DPF Outlet Pipe Heat Shield Contact with Sleeper Rail

M-252-002

(July 2008)

Certain CXU and CHU models equipped with dual exhaust and Mack-cap diesel particulate filter (DPF)

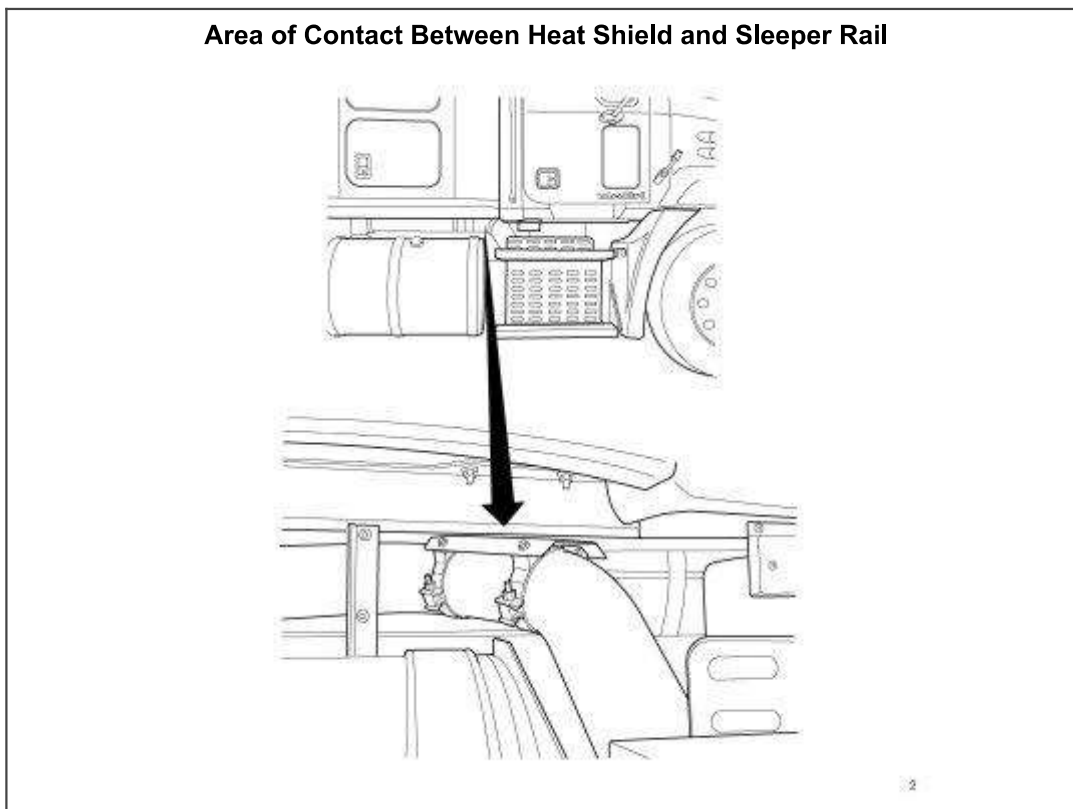
On certain CXU and CHU sleeper model chassis equipped with a dual exhaust and MACK-cap diesel particulate filter (DPF), the sleeper rail may contact the outlet pipe heat shield during up and down movement of the cab. Should this condition be encountered, the existing heat shield must be removed and a new shield (part number 13ME576M) installed on the vertical section of the exhaust outlet pipe.
